TO: CHRISTOPHER J. YUEN, PLANNING DIRECTOR
FROM: DARRYL OLIVEIRA, FIRE CHIEF
SUBJECT: PLANNED UNIT DEVELOPMENT APPLICATION (PUD 07-000007)
APPLICANT: RIEHM OWENSBY PLANNERS ARCHITECTS
OWNERS: TURTLE BAY ENTERPRISES
PROPOSED: PUD-HOLUALOA INN
TAX MAP KEY: 7-6-008:005, 008 AND 030

SUBJECT : **Planned Unit Development Application PUD 07-000007**
Applicant: Riehm Owensby Planners Architects
Owner: Turtle Bay Enterprises
Location: Holualoa, N. Kona, HI
TMK: 3 / 7-6-008:005, 008, 030

SUBJECT: PLANNED UNIT DEVELOPMENT PERMIT-(PUD 07-000007)
Request: PUD: HOLUALOA INN
Applicant: RIEHM OWENSBY PLANNERS ARCHITECTS
Owner: TURTLE BAY ENTERPRISES LLC
Tax Map Key: 7-6-008:005, 008, and 030

Exhibit 11: Right of Way Improvement Variance Request - Subdivision Control Code

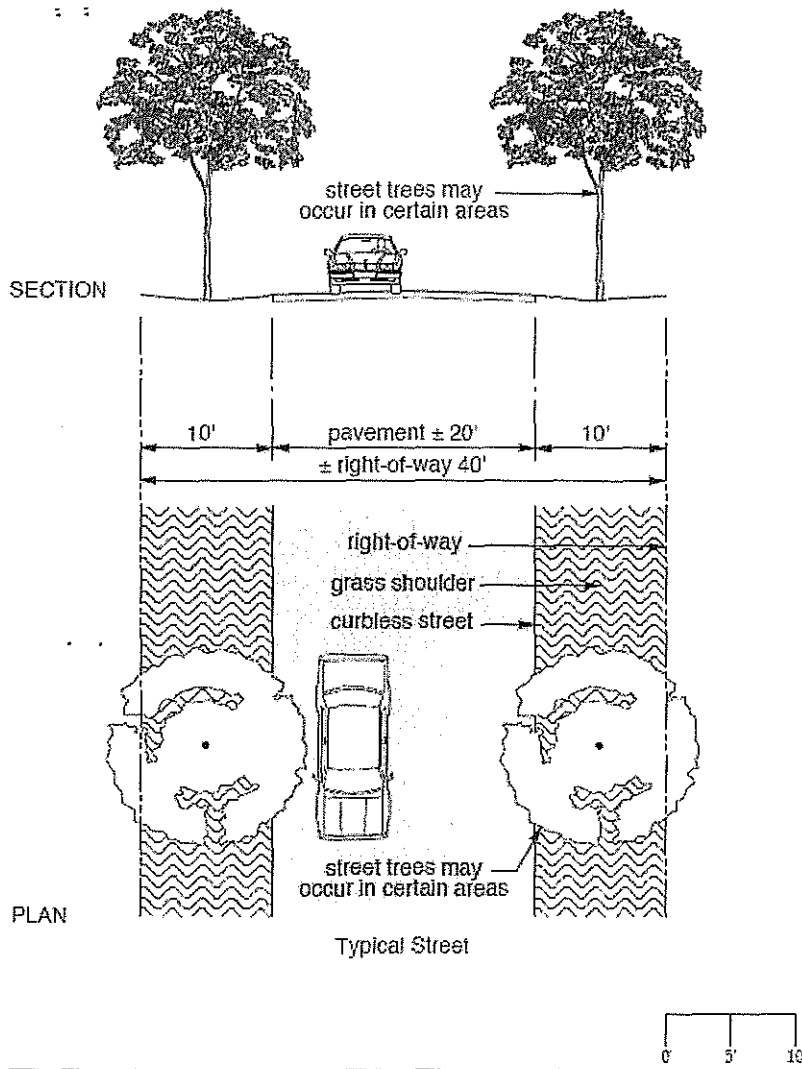
Variance Request No. 16 from HCC Section 23-95 We recommend the entire proposed 40-foot right-of-way be improved. We have no objection to the applicant's geometric design of Exhibit 11, with paving as required by Section 23-86 or approved equal. The roads shall be improved with stabilized shoulders and swales to the required right-of-way or easement width exclusive of cut and fill slopes. If swales are not required, a deed covenant should be required to prohibit construction of walls, berms or swales with the potential to concentrate and divert drainage without proper mitigation as recommended by licensed engineer. This establishes a minimum paving and improvement width standard and permits the geometric design of the applicant's Exhibit 11.

- **Agricultural Street (40' wide road right-of-way in lieu of 50' ROW-Exhibit 11).** The proposed standards for the 40-foot wide agricultural street-type roadway with 20 feet of pavement will deviate from the minimum 50-foot wide ROW specified by DPW Standard Detail R-39. The Applicant is proposing a minimum pavement width of 20 feet with 10-foot wide grassed-stabilized shoulders on each side with no curb, gutters or sidewalks. The relatively large size of the proposed lots warrant a reduced right-of-way since on-street parking is less of a concern when you have such large lots. The paved travel section will meet code, so vehicular movement should not be affected by this variance. The deviations will be directed towards the use of grass shoulders and swales and a reduced right-of-way width.
